Air Quality Impact Analysis Review

**Next Generation Processing, LLC.
Haven Gas Plant
Air Quality Construction Permit Application**

**Source ID No. 1550133
C-10086**

DRAFT

Figure 3. SIL Modeling Isopleths for Annual NO₂

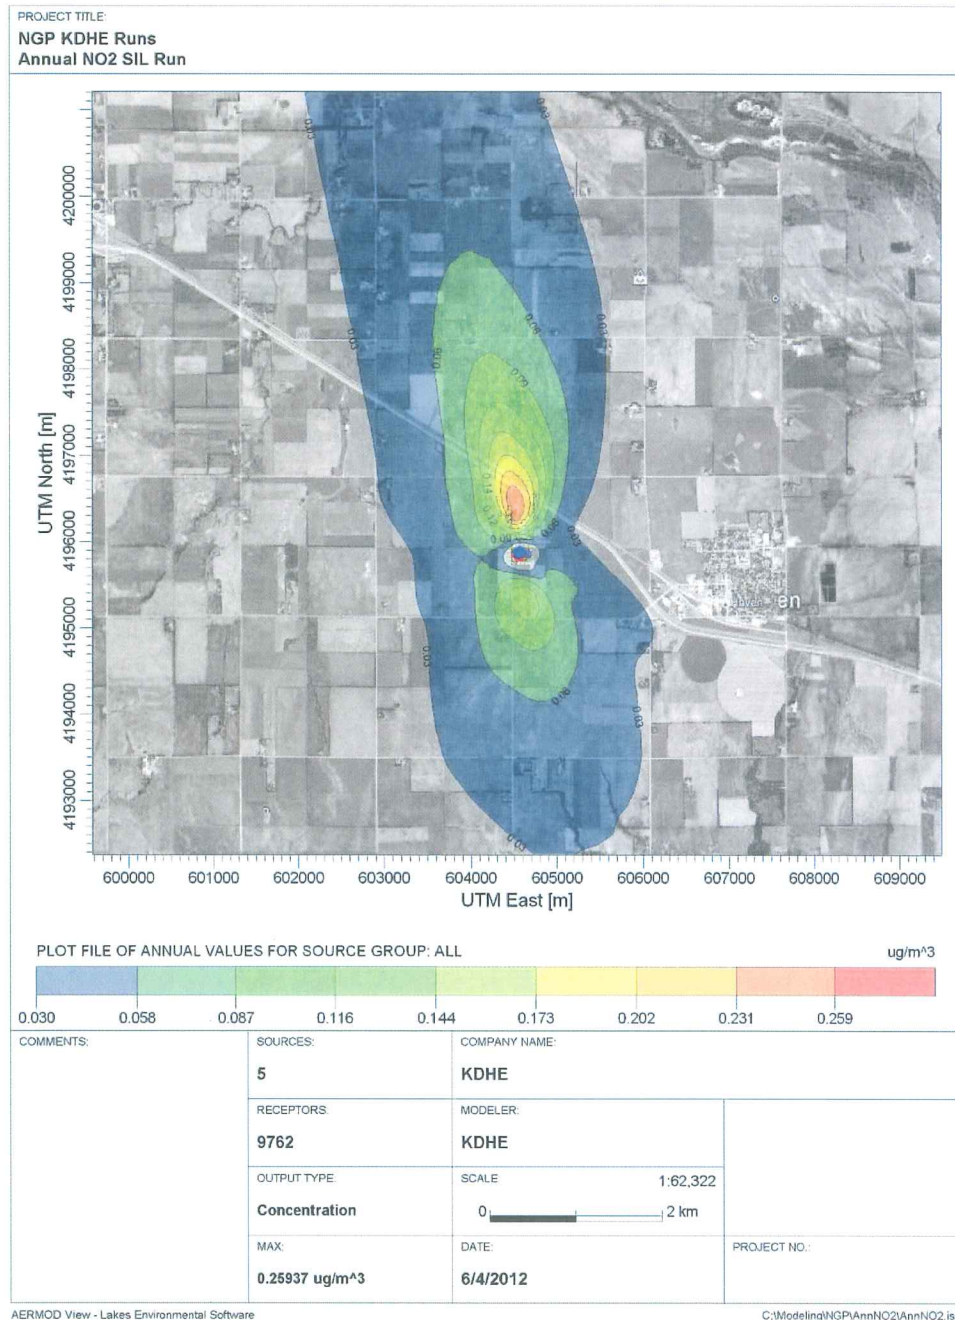
Figure 3 shows isopleths of H1H impacts for annual NO₂. Figure 4 shows isopleths of H1H impacts for 1-hour NO₂ (Tier 1, Scenario 1 analysis, which had the highest impacts). Figure 5 shows isopleths of H1H impacts for 8-hour CO. Figure 6 shows

Figure 6. SIL Modeling Isopleths for 1-hour CO

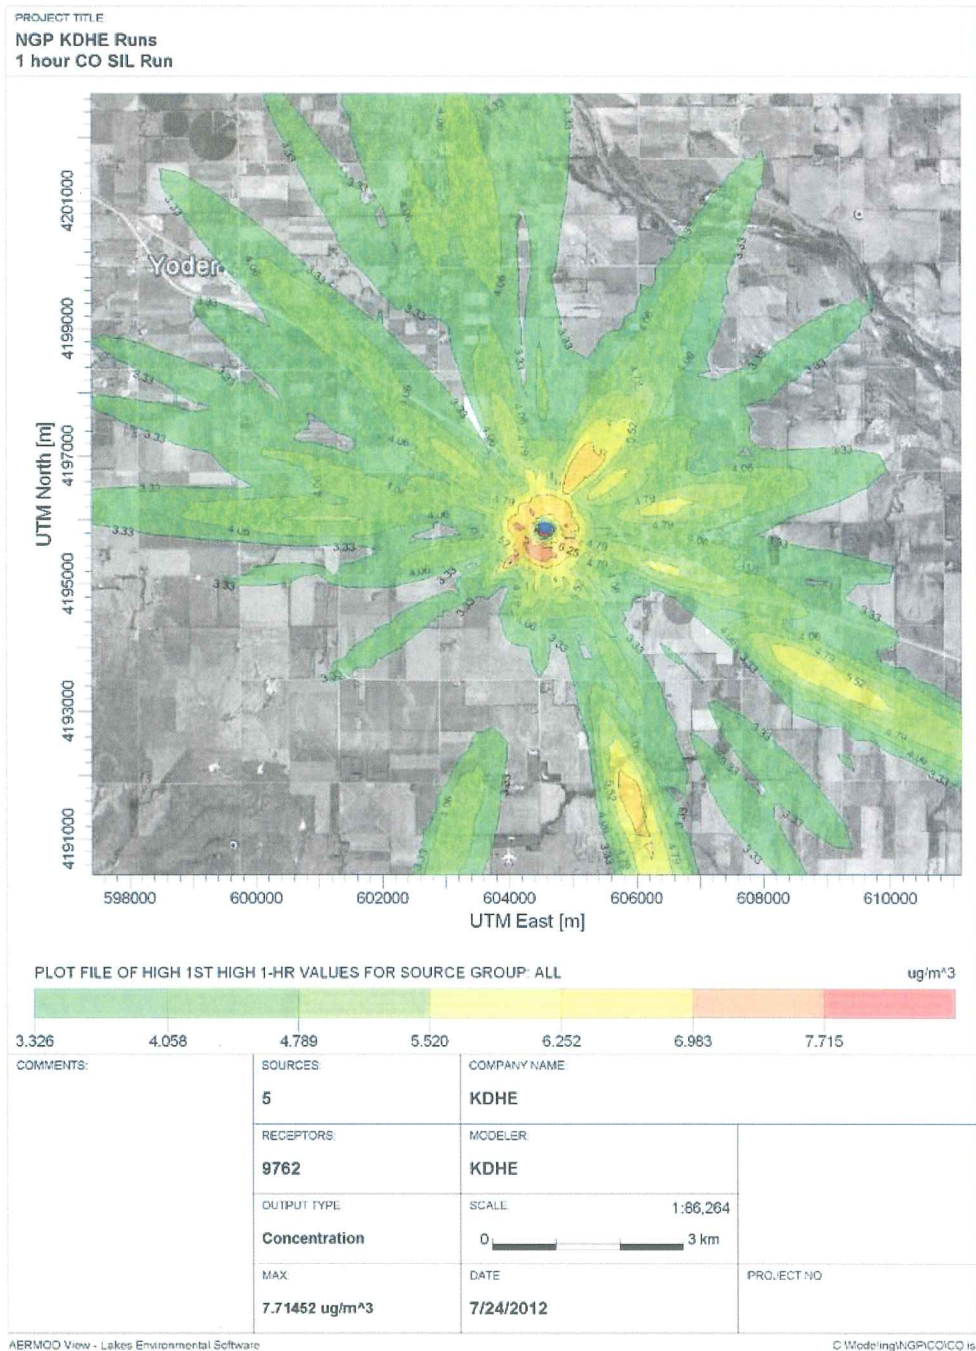
isopleths of H1H impacts for 1-hour CO. Figure 7 shows isopleths of H1H impacts for annual PM_{2.5}. Figure 8 shows isopleths of H1H impacts for 24-hour PM_{2.5}.
